## Change of the Case for the SD Memory Card

NZ1MEM-2GBSD, NZ1MEM-4GBSD, NZ1MEM-8GBSD, NZ1MEM-16GBSD

FA-A-0370-A

Before change	After change

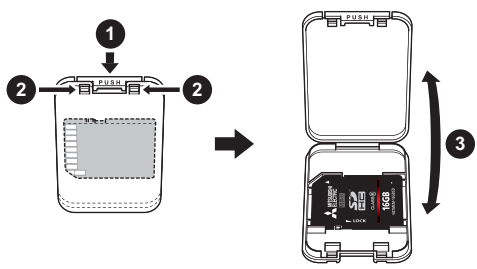
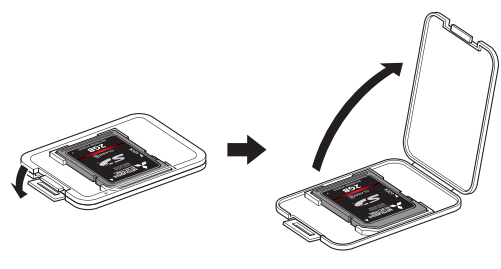
The case for the SD memory card will be changed as follows.

The opening/closing method will also be changed.

<p>① Push in the part where the word PUSH is written.</p> <p>② The claws are off while you press the part.</p> <p>③ Open the case while pushing the part.</p>	<p>Unlock the case to open it.</p>
